**RESPONSE TO
PLANNING
OBSERVATIONS**

**PROPOSED
REDEVELOPMENT**

**10 CHRISTCHURCH
HILL, HAMPSTEAD
LONDON NW3**

November 2014

Midsummer's Day

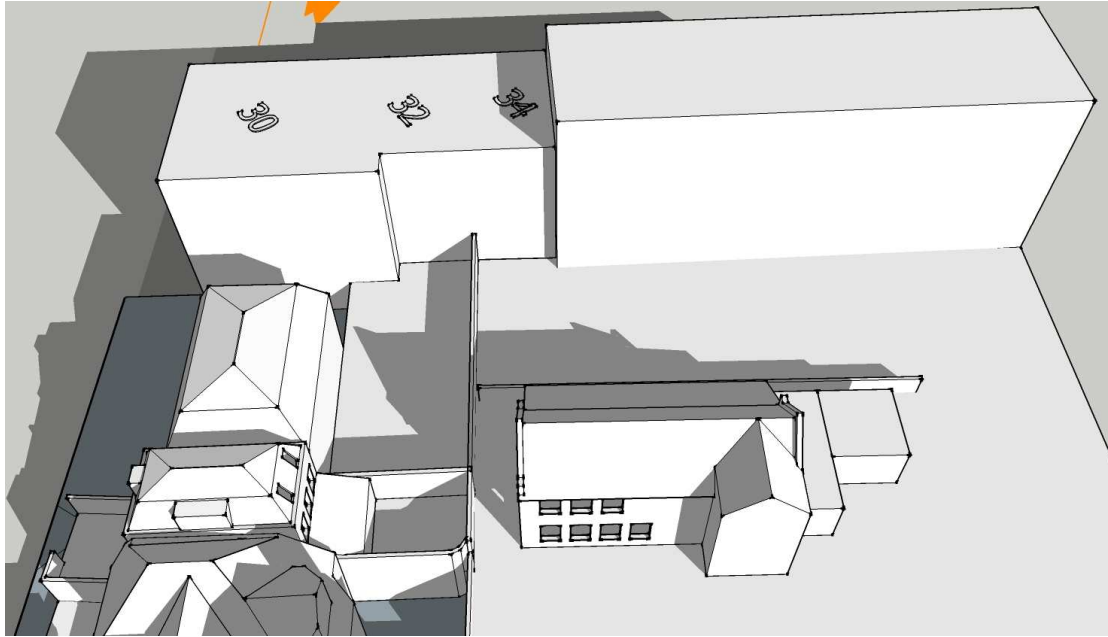
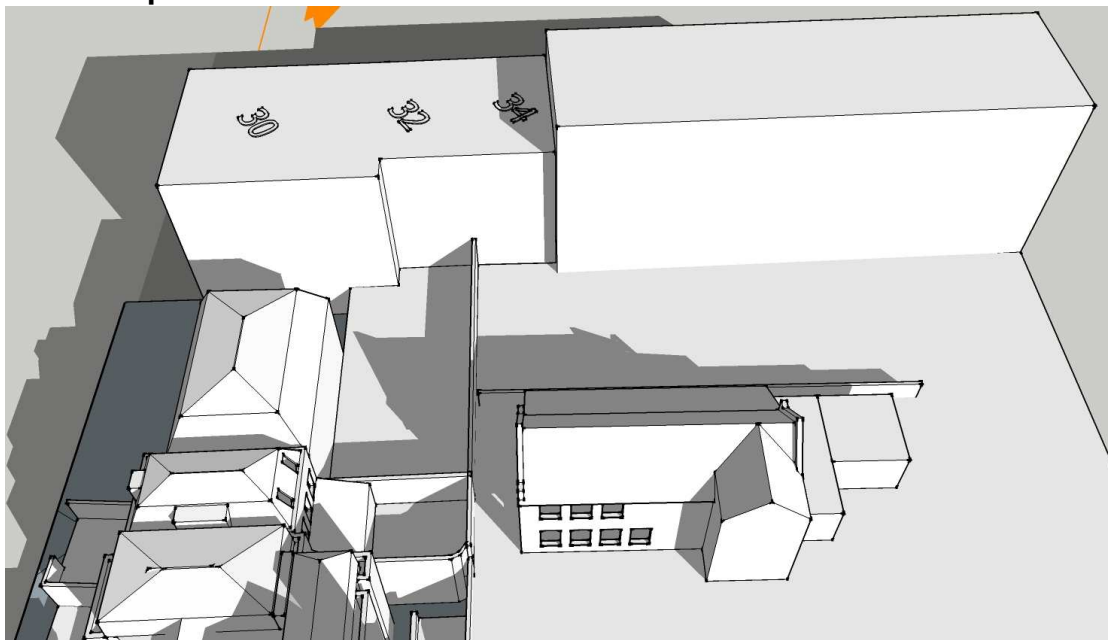
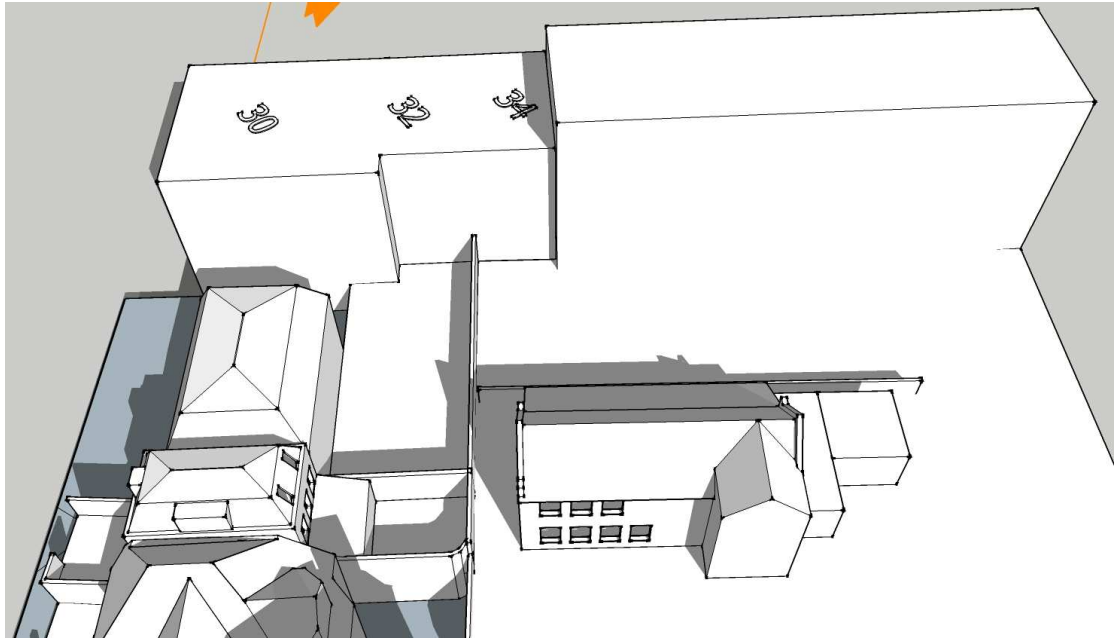
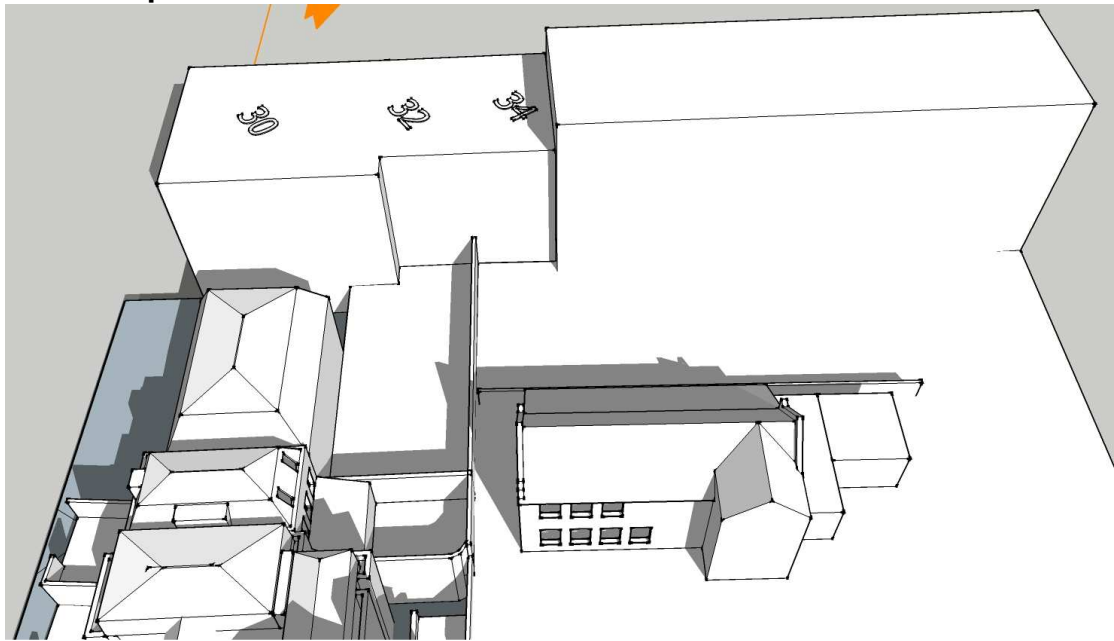
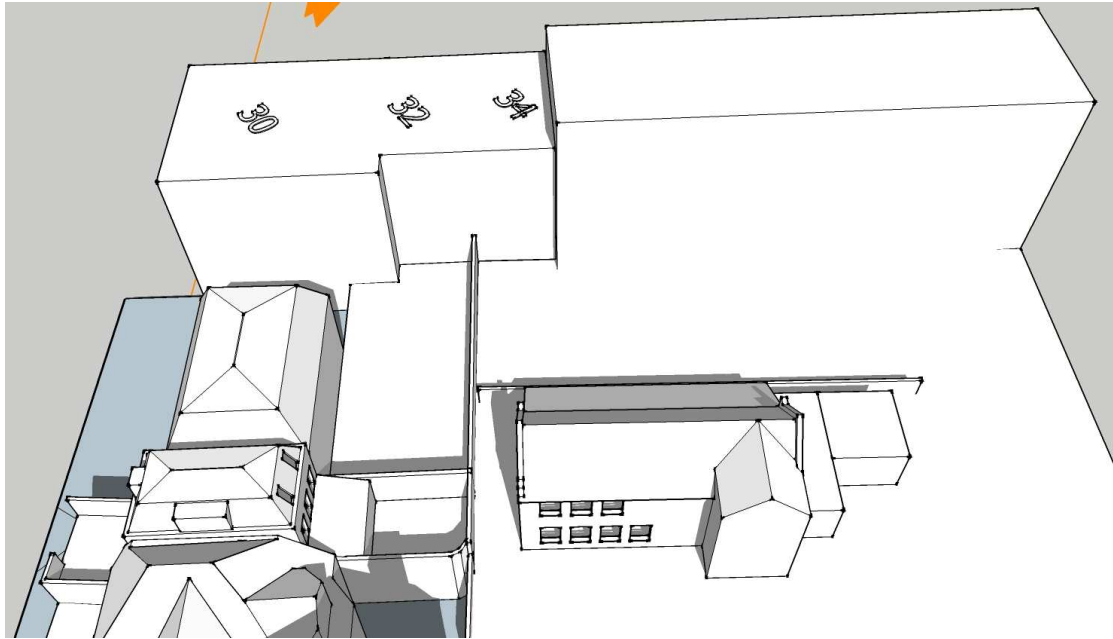
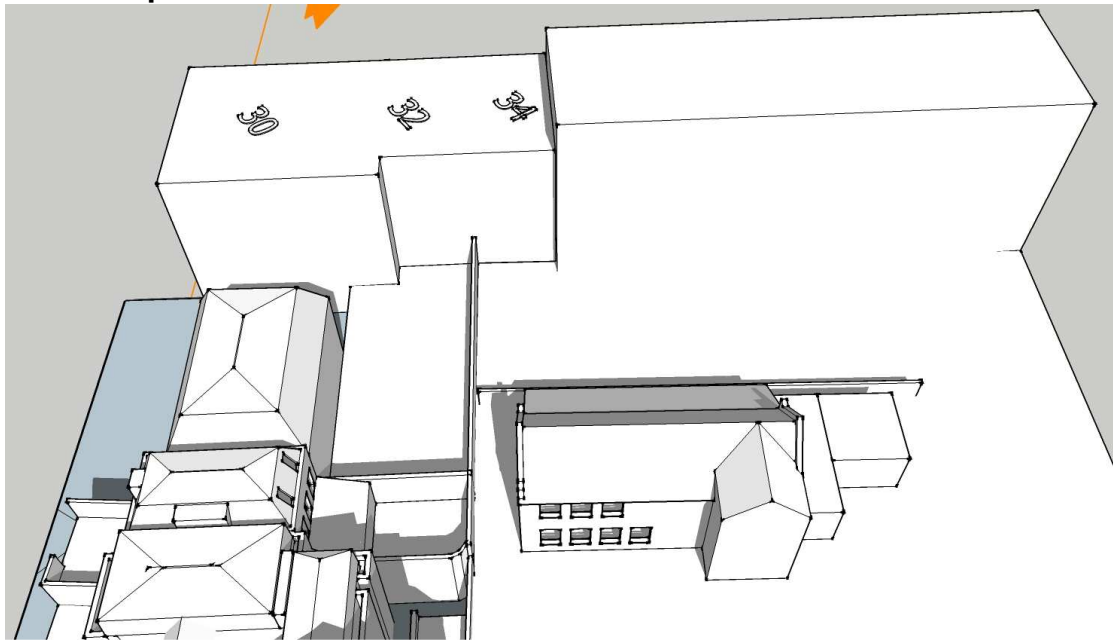
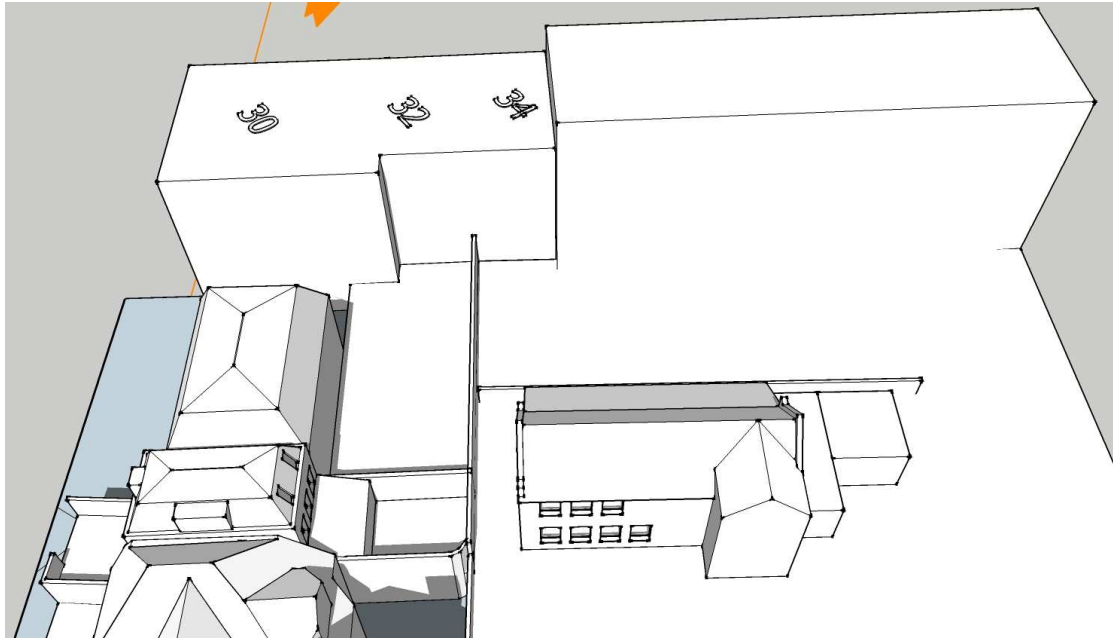
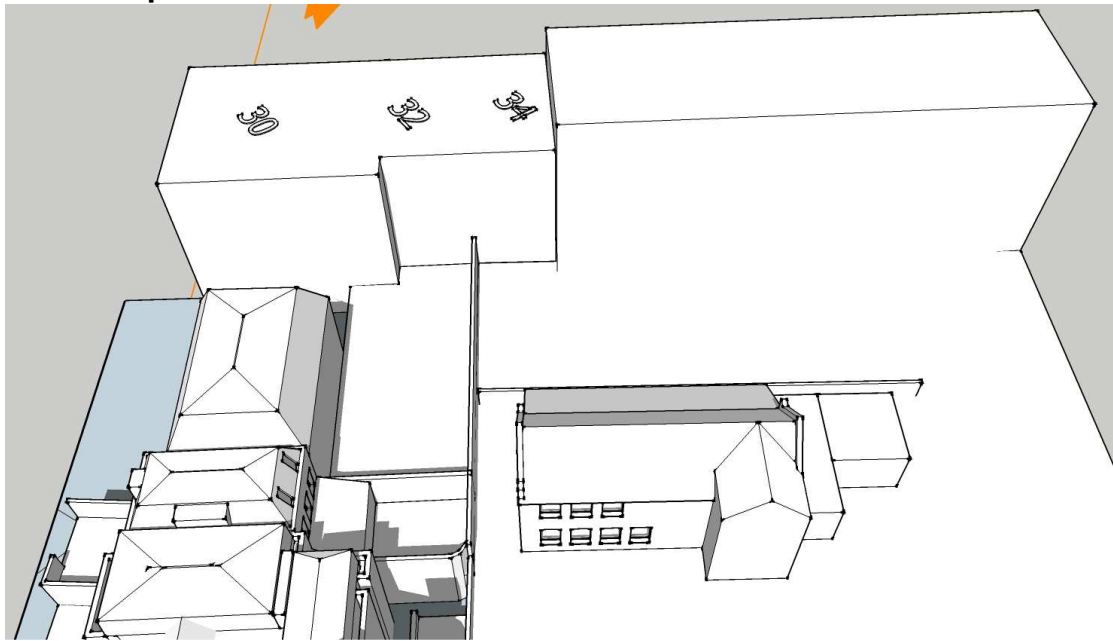
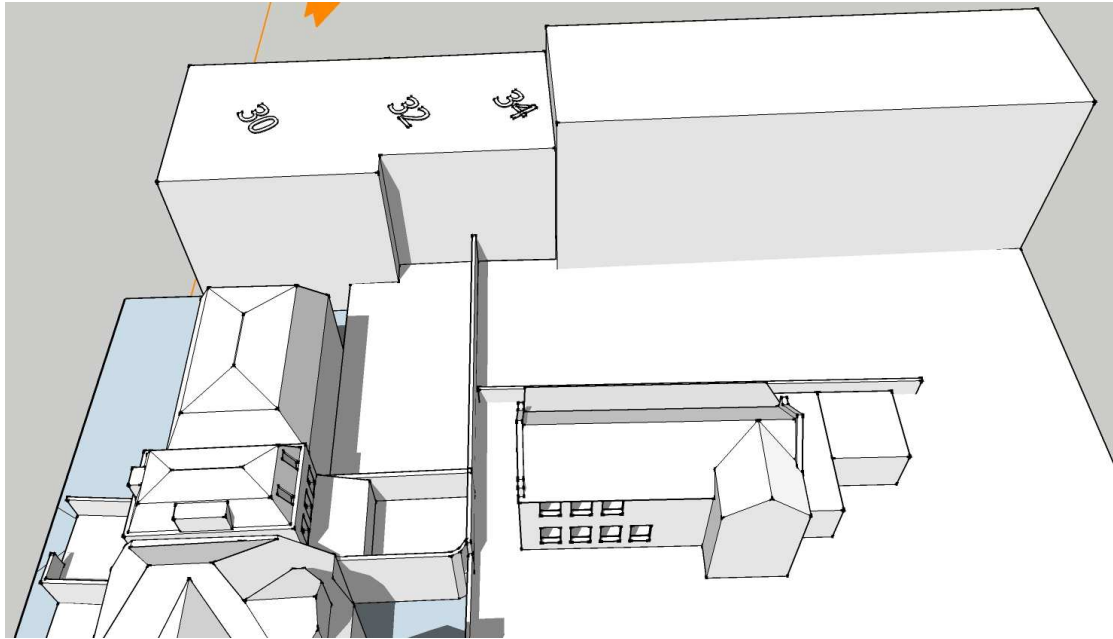
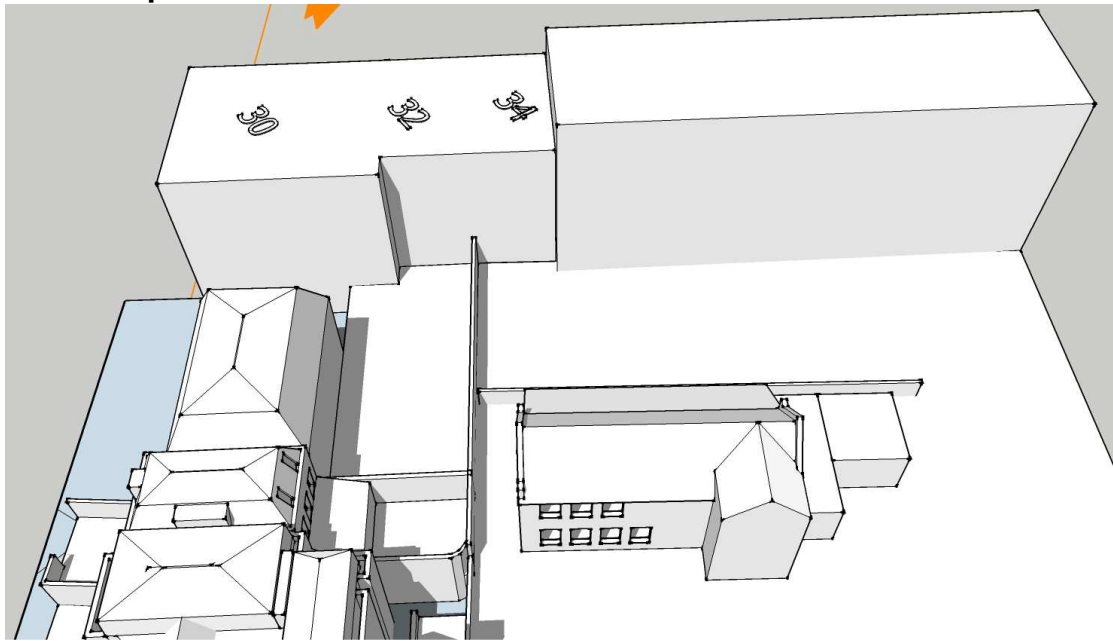
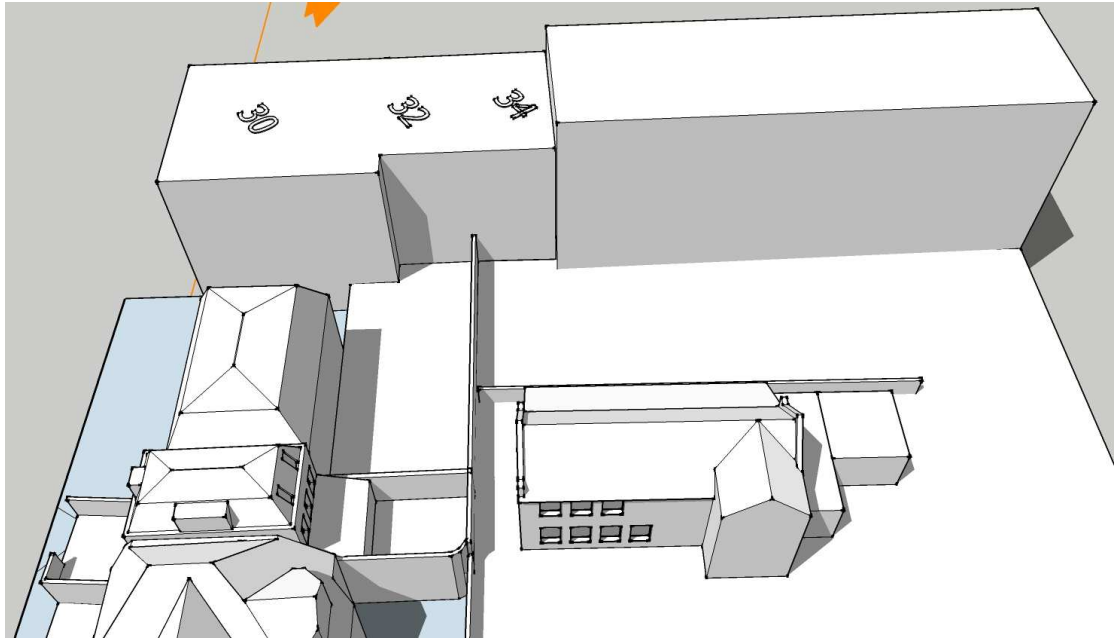
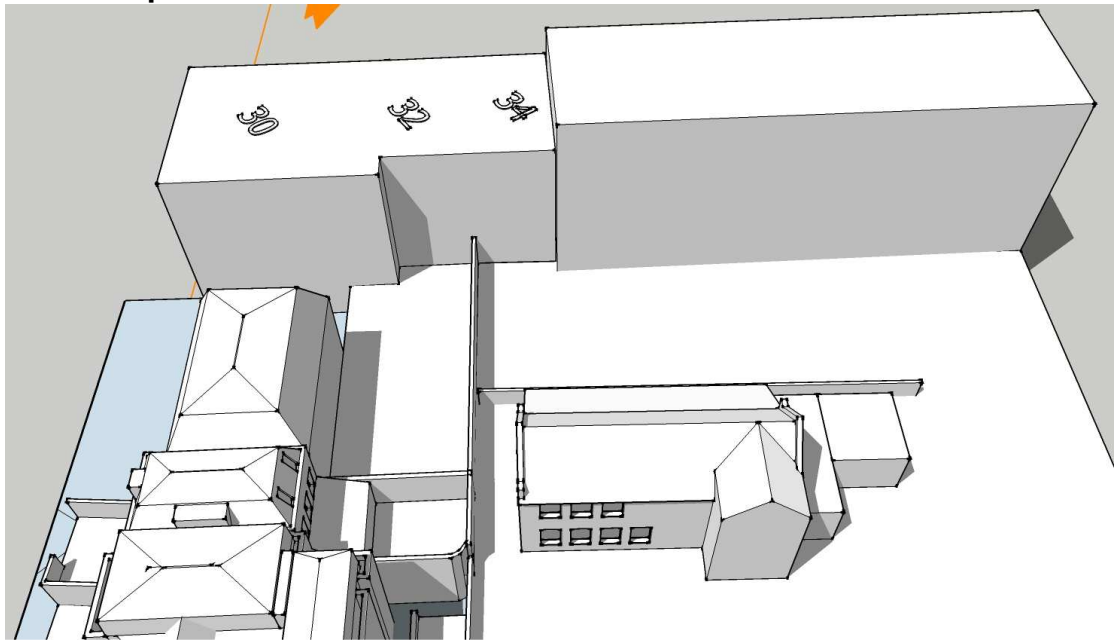
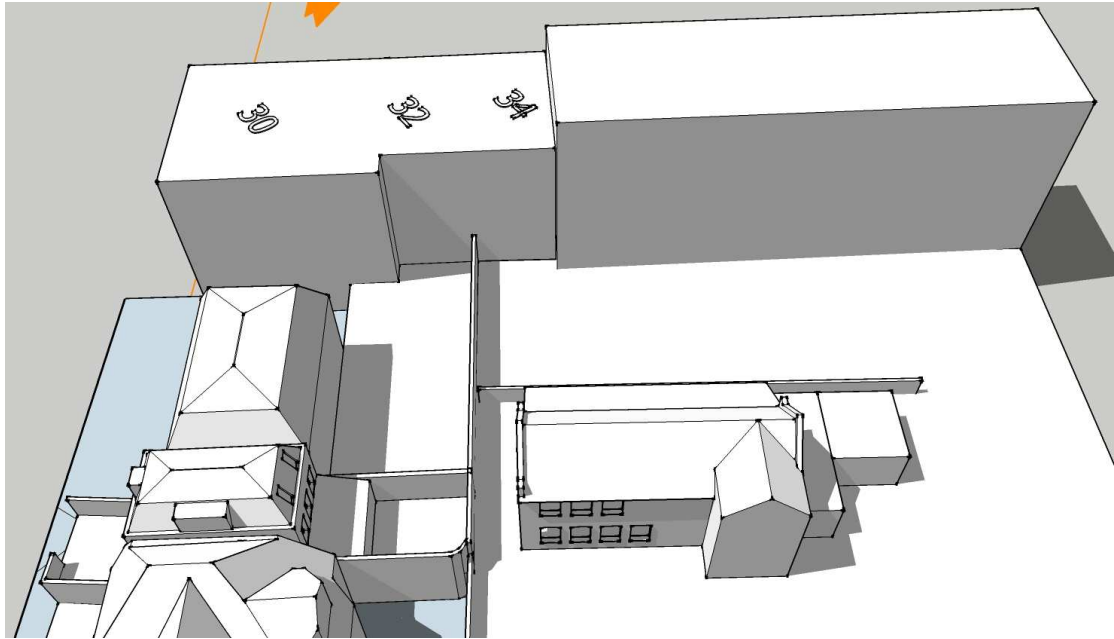
- The proposed development with its higher roofline which continues for a longer length (perpendicular to Christchurch Hill) and is also wider (parallel to Christchurch Hill), will impact the light at the back of 34 Well Walk, both in respect of the rear ground floor windows and also the patio, and will be especially acute during the Autumn to Spring months when the sun is lower and natural sun light is already somewhat limited. The Daylight & Sunlight Report submitted for this application is at a time of year which seems to drastically underestimate the effect of the proposed building given the sun is much higher in the sky in the period analysed vs. the Autumn to Spring months.
- The proposals will impact on light levels on the front gardens of nos. 13 and 14 Gainsborough Gardens and the rear gardens of 11, 12 and 13 of the same street.

As regards 34 Well Walk, it is averred that our analysis was made at an adjusted time of year to improve the apparent effects on the rear of this building and “to drastically underestimate the effect of the proposed building”. This is not the case as the initial shadow diagrams were compiled for the Equinox (21st March and 21 September). In response to this allegation, however, we have compiled proposed and existing analyses of the situation at the rear of 34 Well Walk at hourly rather than two-hourly intervals and at the Equinox, Midsummer’s Day (21st June) and Midwinter’s Day (21st December). These are set out below.

As can be seen from these images, there is no effect whatever on the sunshine reaching the rear of 34 Well Walk or its patio caused by the proposals on either Equinox nor Midwinter’s Day nor Midsummer’s Day. The assertion made is, therefore, without any foundation whatever and our original report does not underestimate the effects, drastically or otherwise, of the proposed building.
